### **STAFF REPORT**

**RZ/FDP 2014-SP-005**

**PROPOSAL:** To rezone 4.51 acres from R-1 to PDH-2 for the development of seven single-family detached dwelling units at an overall density of 1.55 du/ac.

# CONCEPTUAL / FINAL DEVELOPMENT PLAN CORBETT MANOR

CONCEPTUAL / FINAL DEVELOPMENT PLAN  
**CORBETT MANOR**  
SPRINGFIELD DISTRICT  
FAIRFAX COUNTY, VIRGINIA

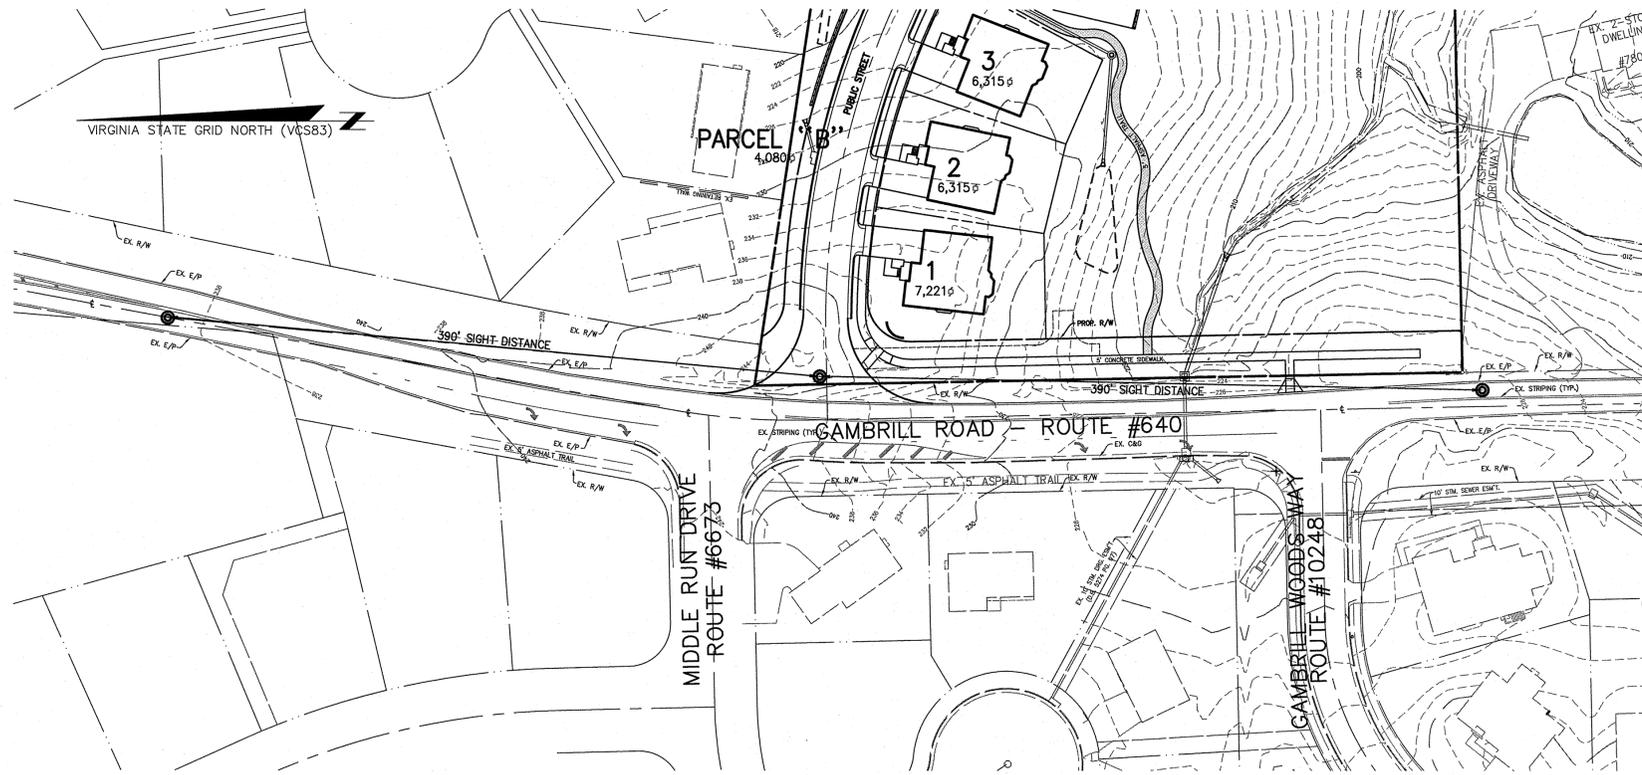
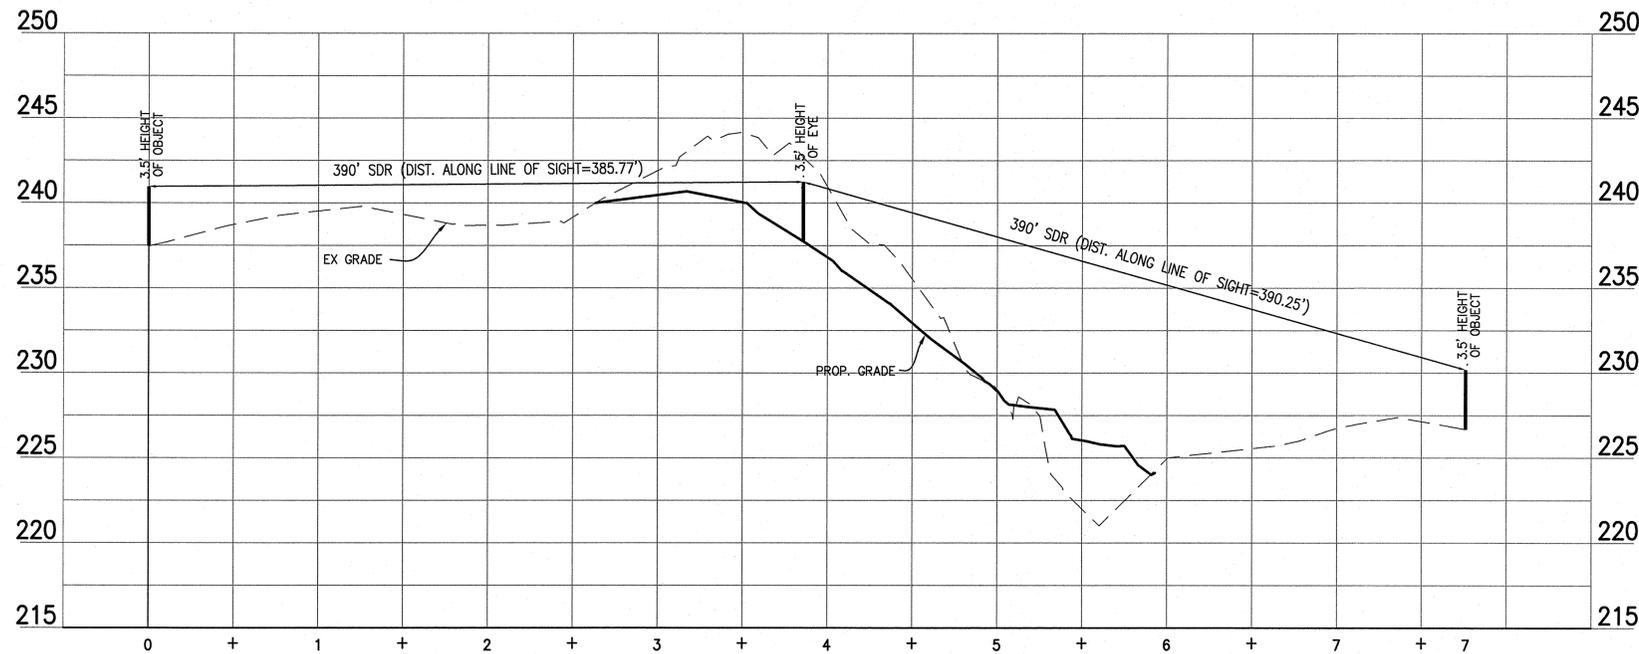
Staff noted that the development plan depicts the limits of a field-verified RPA and the more extensive limits of an EQC (see Appendix 7). In order to ensure that no degradation occurs in the EQC as a result of construction, staff recommended that the applicant commit to the provision of native plantings and restoration between the edge of the development, particularly on the southern boundaries of Lots 4, 5, 6 and 7, and the northern boundary of the field-verified RPA. Staff recommended that the EQC be protected and preserved as open space.

Staff noted that much of the existing vegetation located in the stream valley is proposed to be preserved. Staff strongly encouraged the applicant to protect the environmentally-sensitive EQC/RPA from land disturbance during development by installing a super-silt fence along the southern edge of the lots and encouraged the applicant to work with the Urban Forestry Management Division (UFMD) of DPWES to augment the proposed landscape plan, particularly in the area between the southern lot lines of Lots 4 through 7 and the RPA.

- Sheet 4 of the development plan proposes an offset intersection which may pose operational and safety conflicts at the Middle Run Drive/Gambrill Road and the new street intersection. However, other plan sheets provide three design concepts for review, of which, FCDOT recommends Option "B," which should be incorporated in the final plan for Sheet 4 for the development. This option proposes a center two-way left turn lane on Gambrell Road, a northbound through/right-turn lane into the new subdivision, and maintains a southbound through lane, as well as right-turn lanes to Middle Run Drive and Gambrell Woods Way. The applicant should design and construct this roadway to meet VDOT standards.

In response, the applicant has committed to the construction of a continuous 1.5-foot tall knee/seat wall along the rear lot lines of Lots 4 through 7. Fringe plantings would be installed behind the knee wall to further limit encroachments into the EQC. The additional planting of native overstory tree, understory tree, and shrub seedlings within the EQC, along with soil amendments and a seed mixture appropriate for woodland openings, would help stabilize the area, promote water infiltration, provide erosion control, and promote biodiversity.

**LANDSCAPE PLAN**

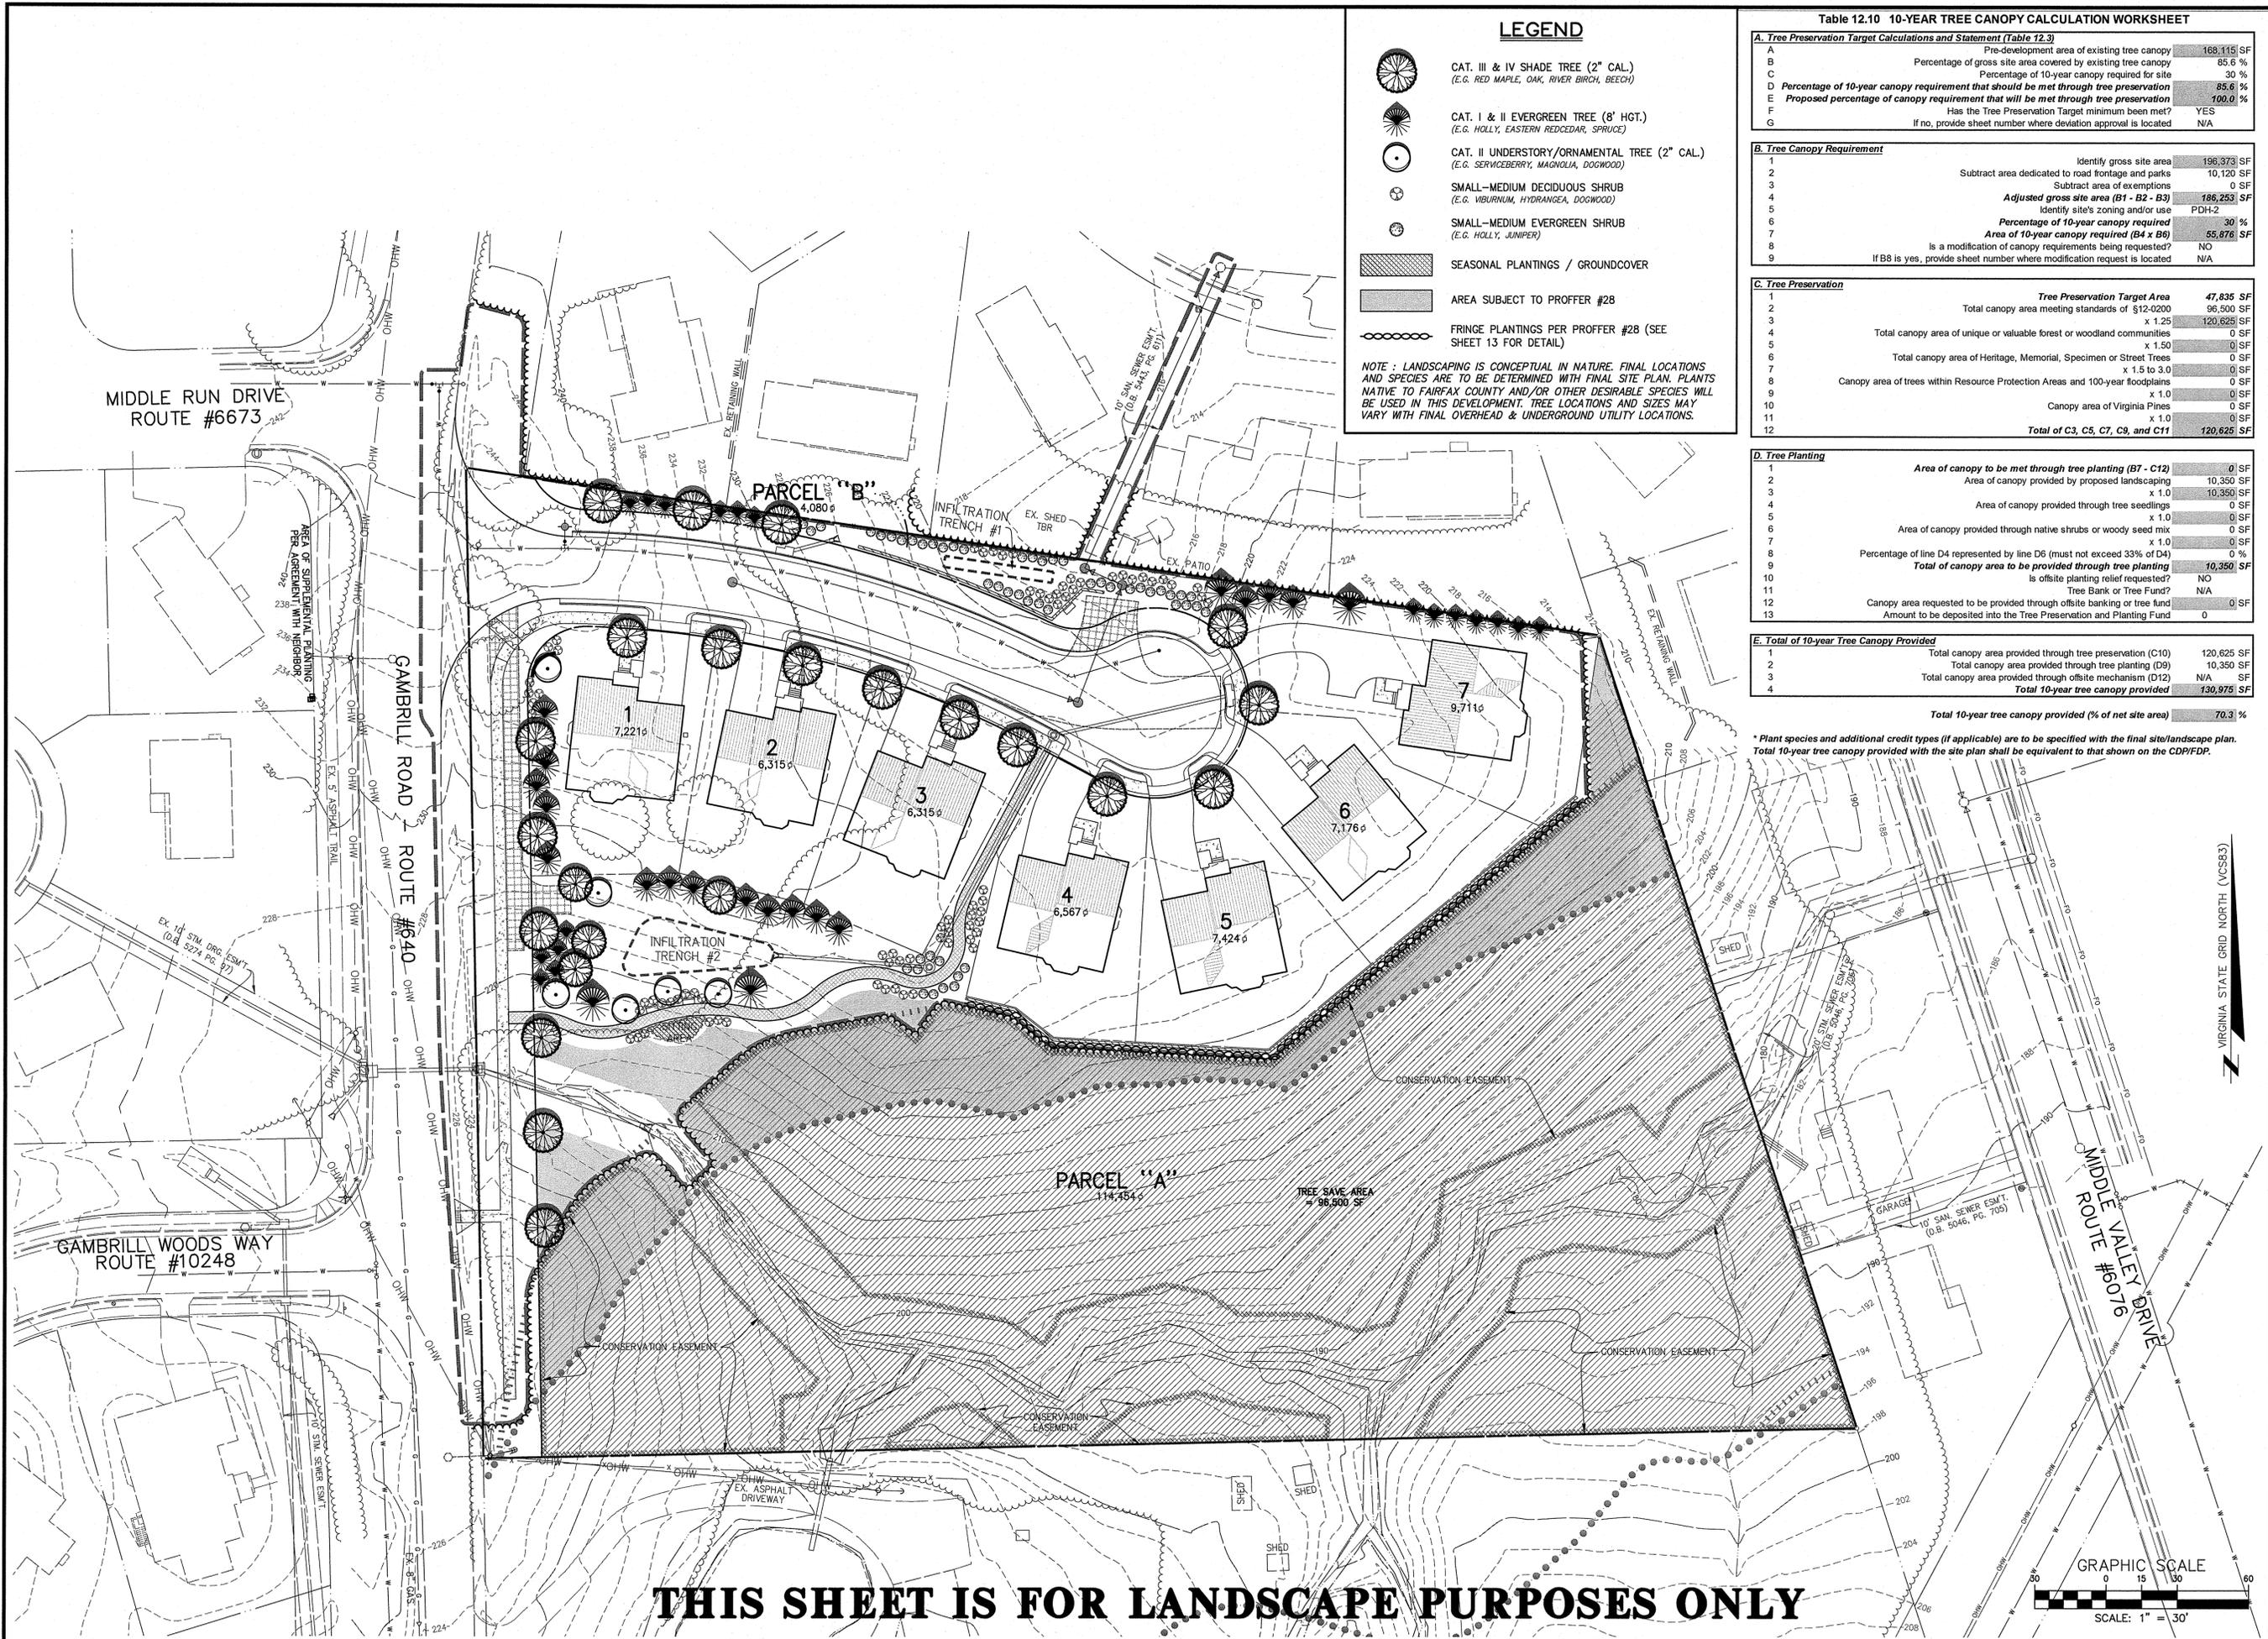
The plans and proffers were reviewed by the Urban Forest Management Division (UFMD) (see Appendix 8). Given the high quality of vegetation on the site, staff recommended proffers regarding the submittal of a landscape plan and commitments to tree preservation, including the restoration of the EQC, HOA management of common open spaces, and HOA property boundary delineation.

Sheet 7 of the CDP/FDP provides details regarding the landscape plan. Additionally, the draft proffers contain various commitments regarding tree preservation. These include the submission of a tree preservation plan, walk-throughs, conformance to the limits of clearing and grading, fencing, root pruning, monitoring, mulching, tree protection signage, and tree value determination.

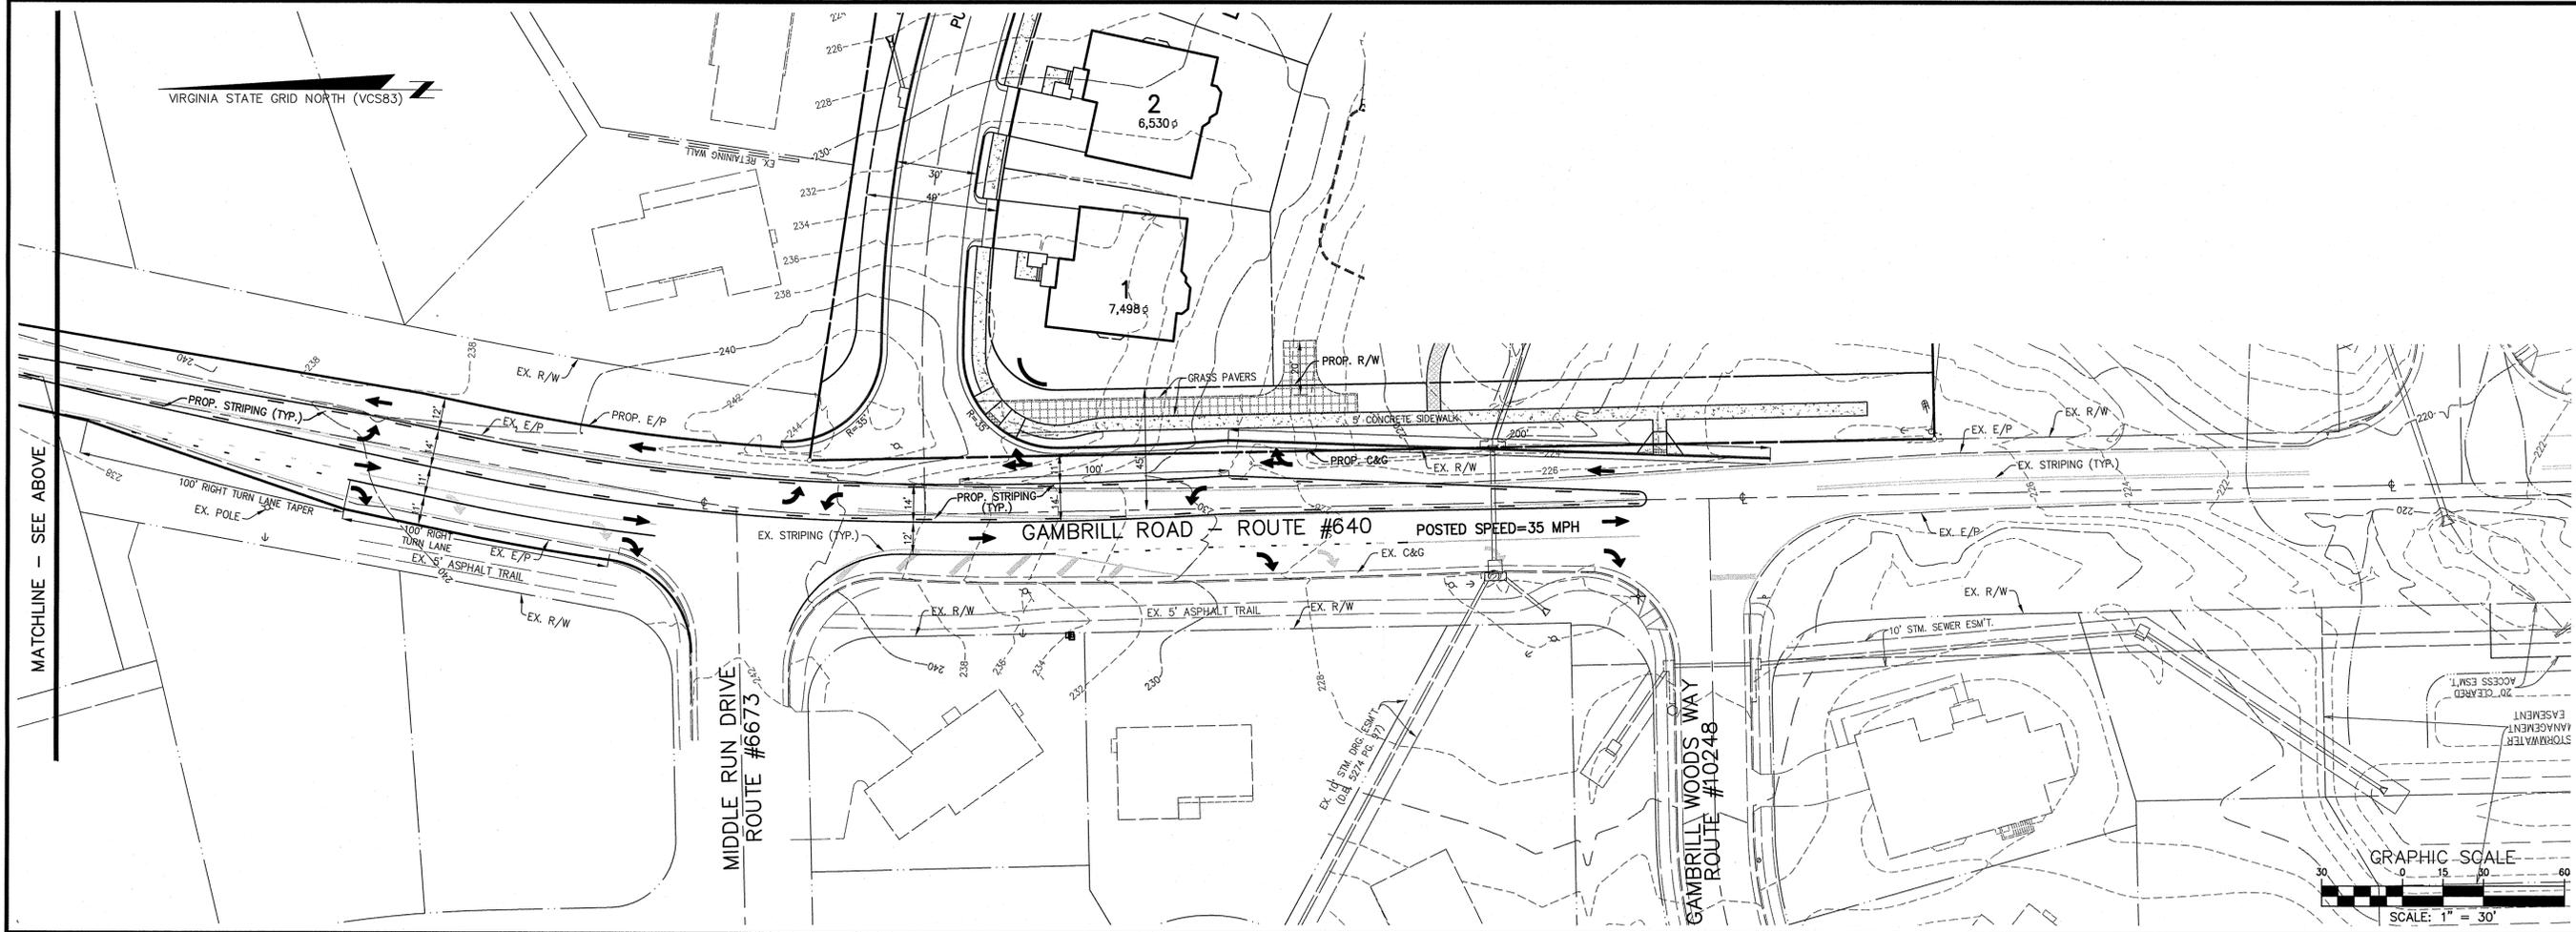
The applicant coordinated with FCDOT and VDOT regarding through and turn lanes on Gambrill Road. The proposed alignments are depicted on Sheet 14. The proposed solution would provide northbound and southbound through lanes along with a continuous left-turn lane, which would accommodate both southbound left turns into the project site and northbound left turns onto Middle Run Drive. Gambrill Road would continue to have dedicated southbound right turn lanes into both Middle Run Drive and Gambrill Woods Way.

32. Gambrill Road Improvements. The applicant shall provide roadway improvements generally as shown on the CDP/FDP, subject to review and approval by VDOT, including approval of any modifications and waivers, including provision of turn lanes/transitions, lane widths, roadway striping, curb and gutter, as generally illustrated on Sheet 14 of the CDP/FDP labeled “Gambrill Road Improvements,” prior to the issuance of the first RUP.
